22-26 Vine Hill

S73 Application

27.09.23

This document sets out the proposed design updates to the approved planning application for works to 22-26 Vine Hill (2021/1150/P).

7 Warner Yard Roof Plan

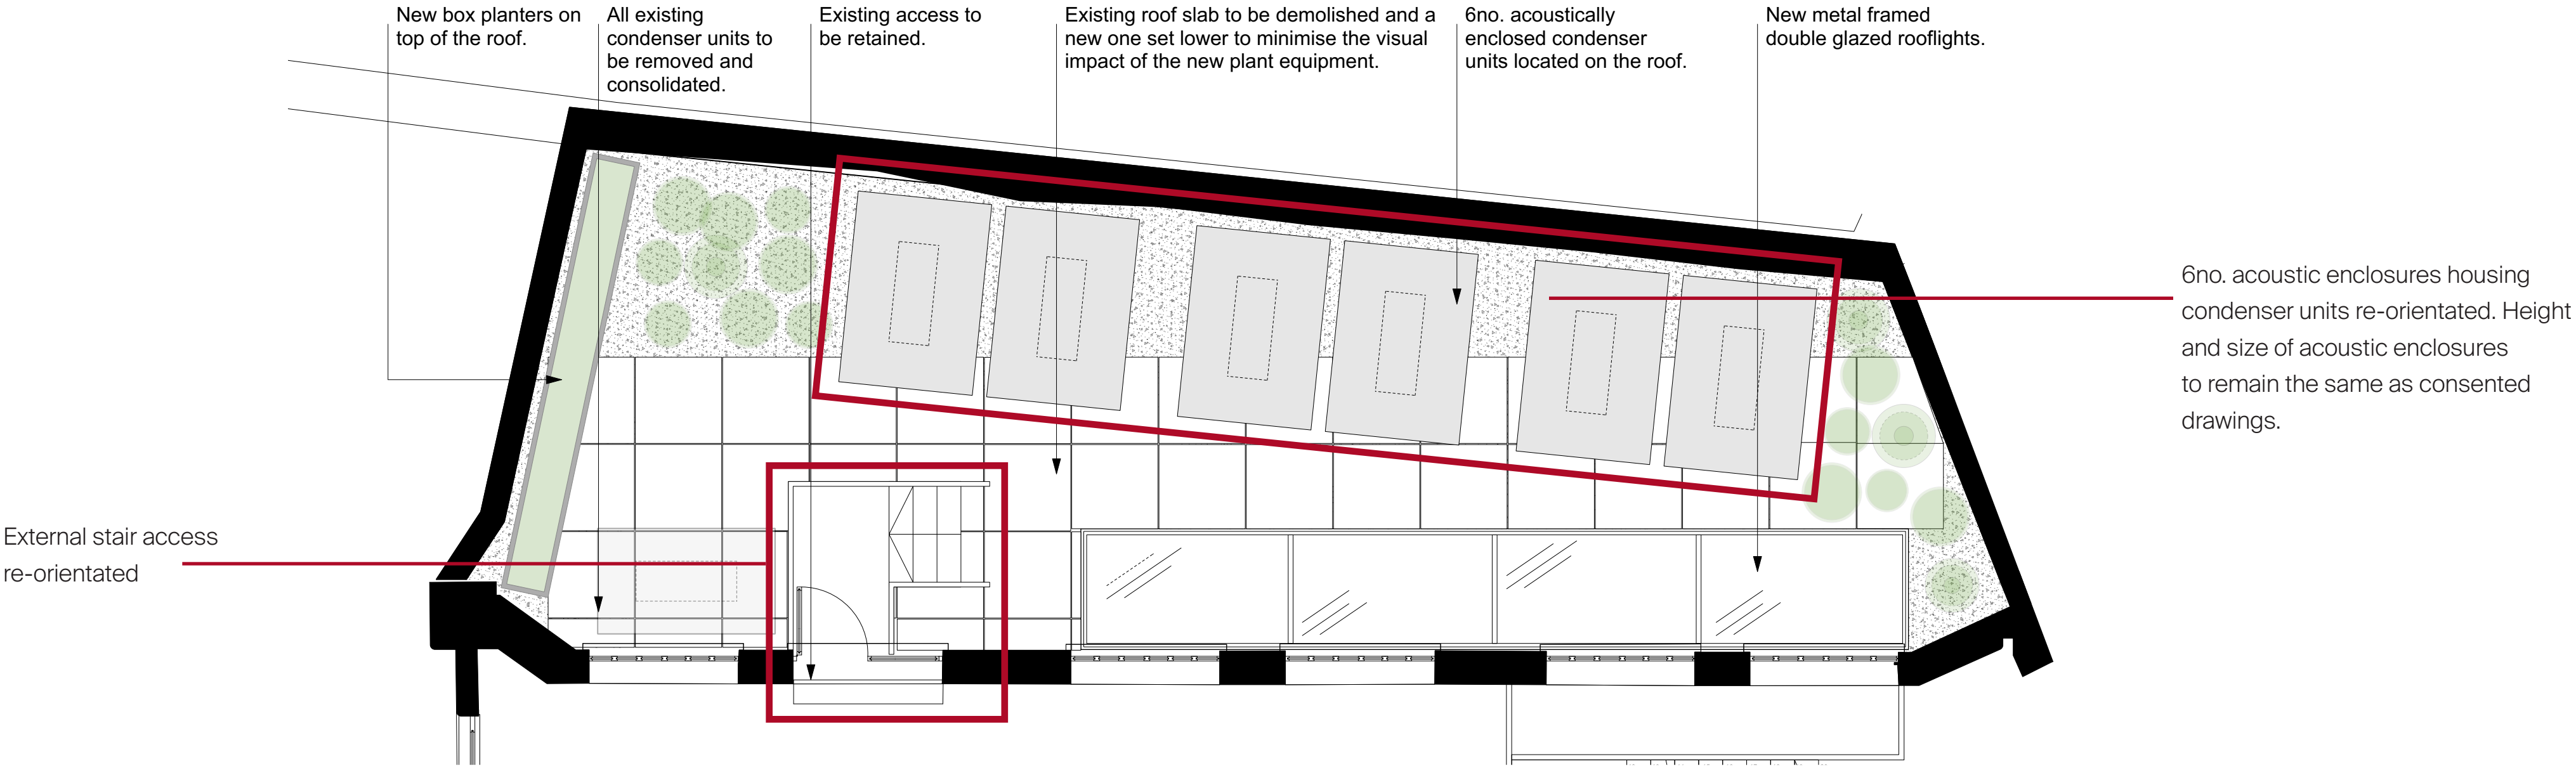
6no. acoustic enclosures housing condenser units re-orientated. Height and size of acoustic enclosures to remain the same as consented drawings.

External Fence/Gate Details

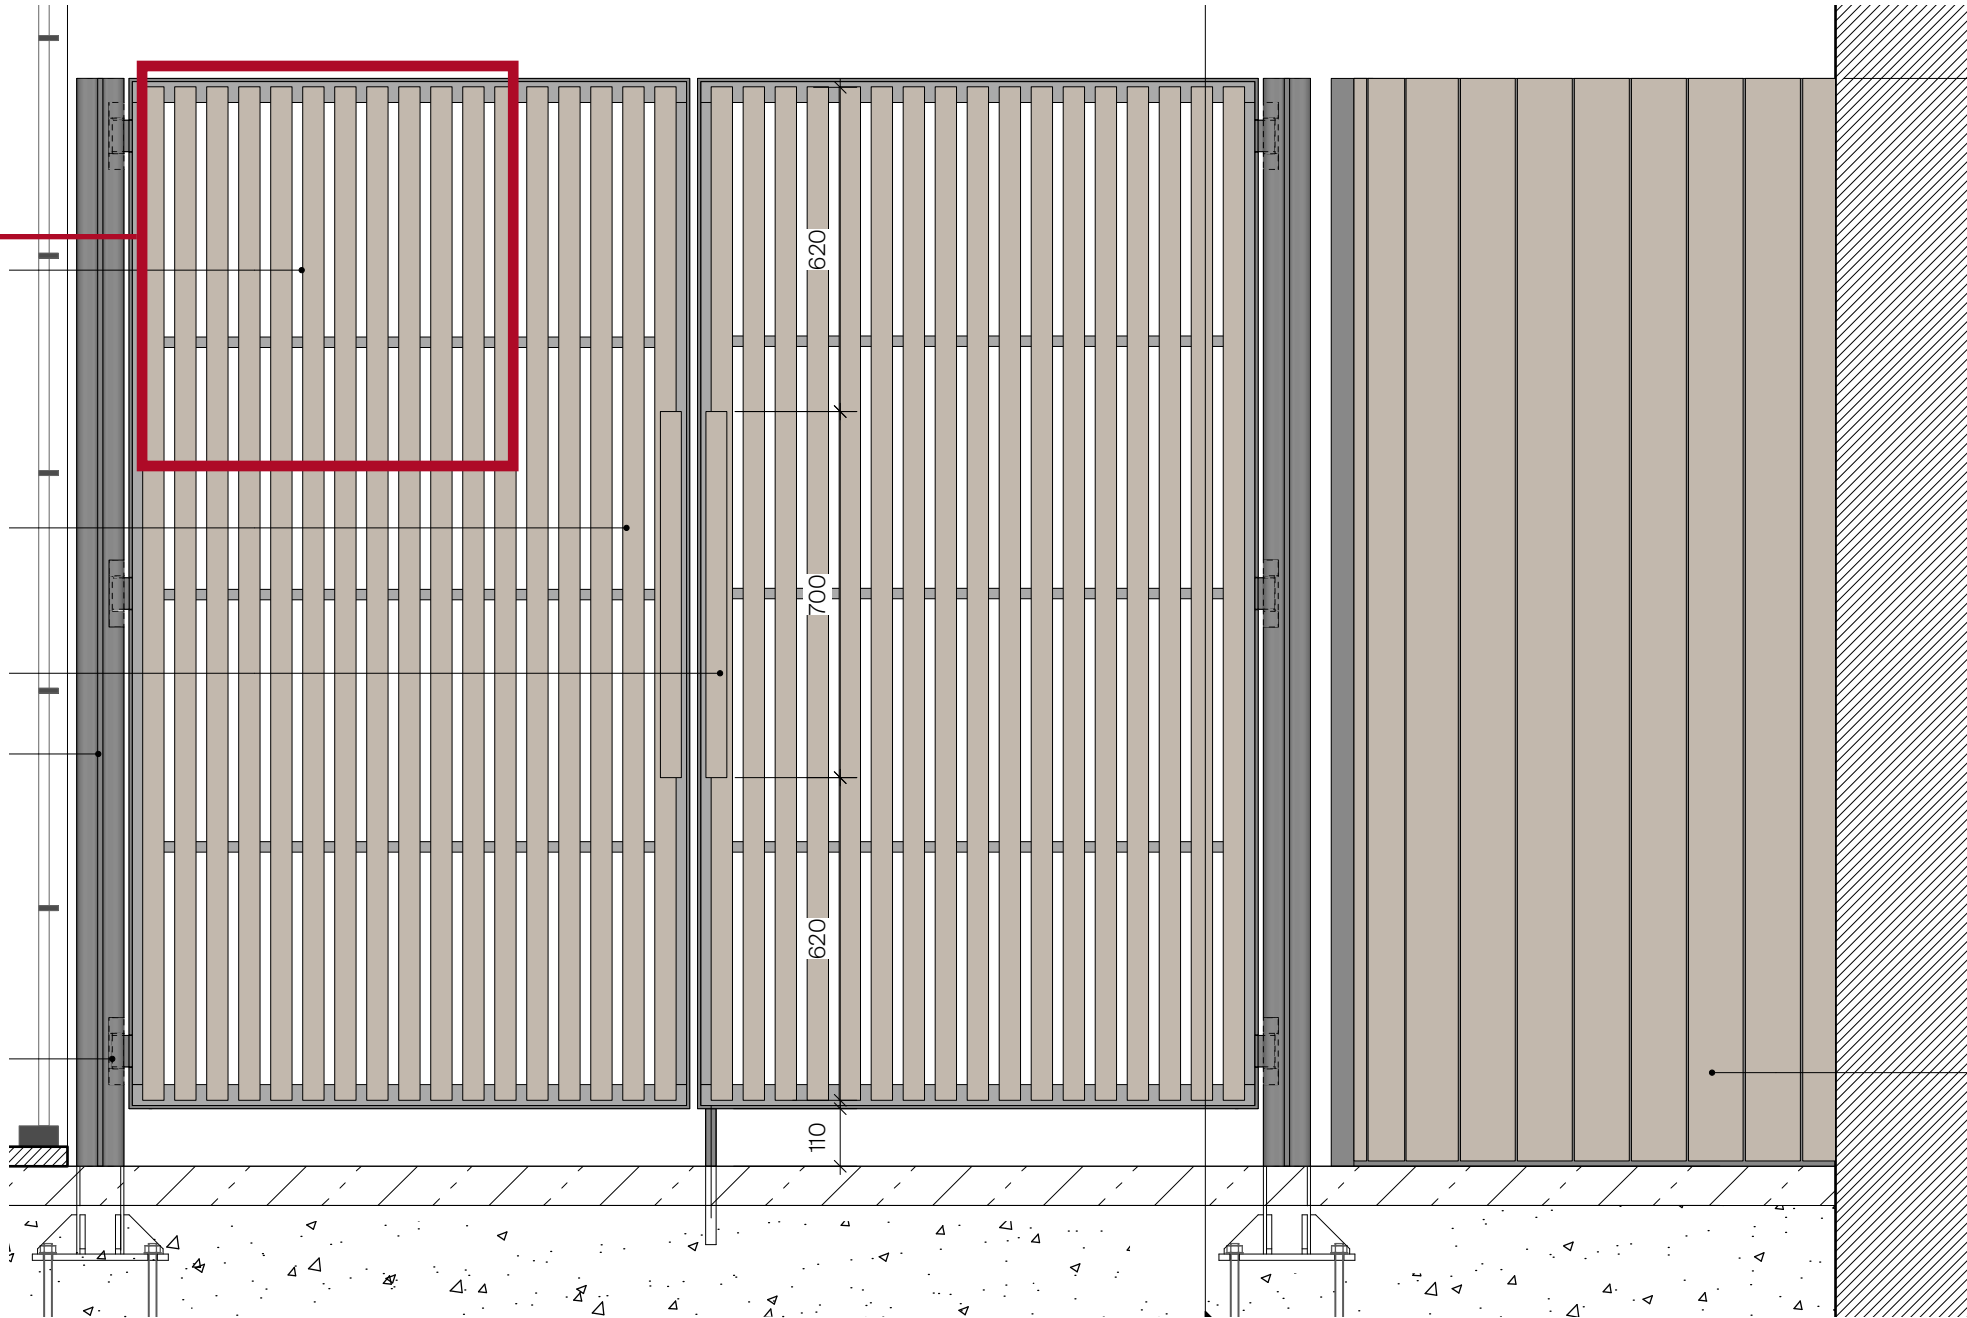
Vertical members of external gate changed from galvanised and patinated metal to timber to match bin and bike store adjacent . Spacing of vertical timbers increased from 10mm to 20mm.

The structure of the gate is to remain metal.

Proposed East Elevation

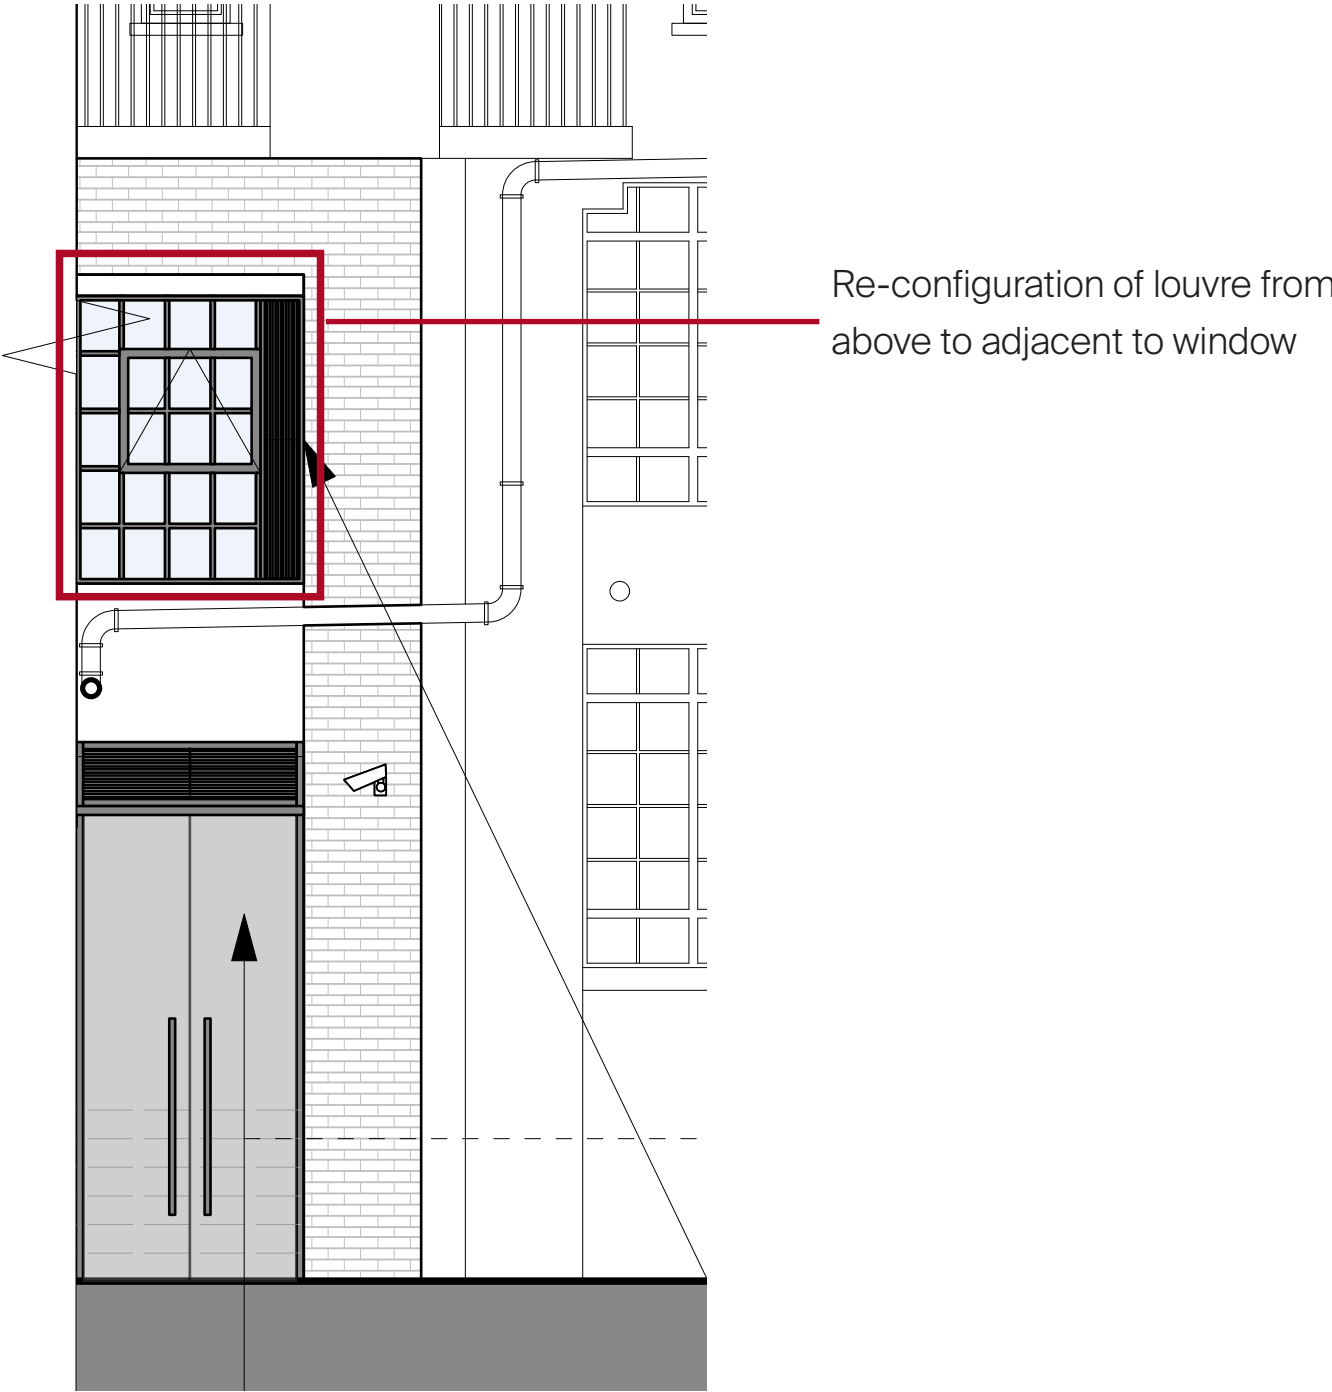
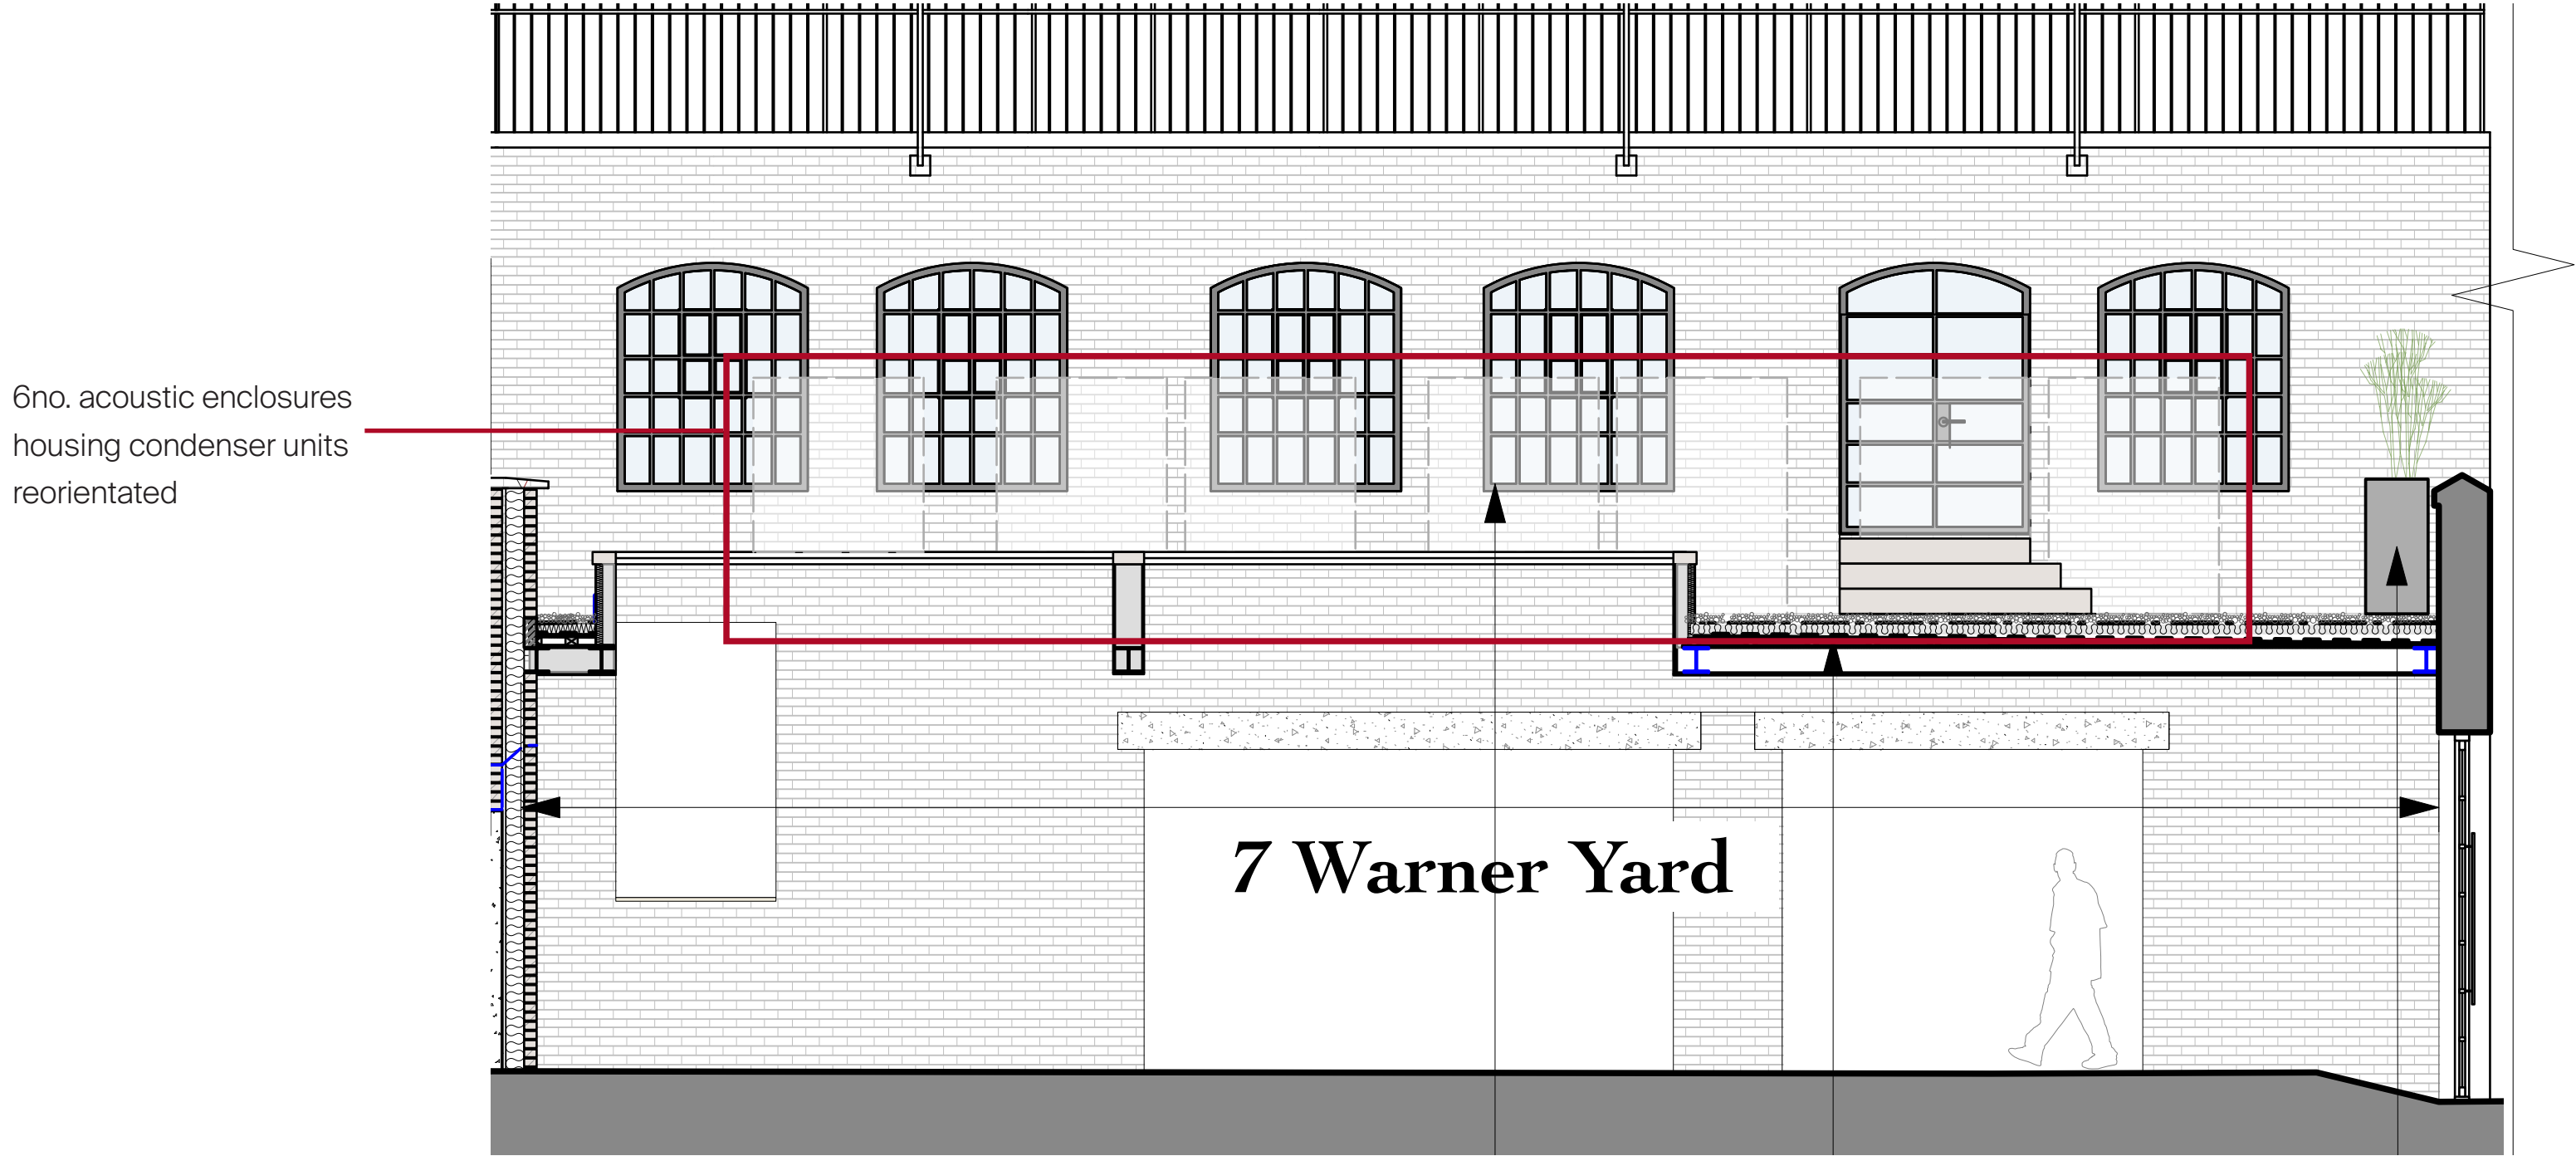
Timber sample received of Solid Larch, Finished HR Prof Euro Class Band Cetol WF 771 Semi-Transparent Concrete Grey Wood Finish.

This timber is to be use for the adjacent refuse and bike store in Vine Hill Yard.
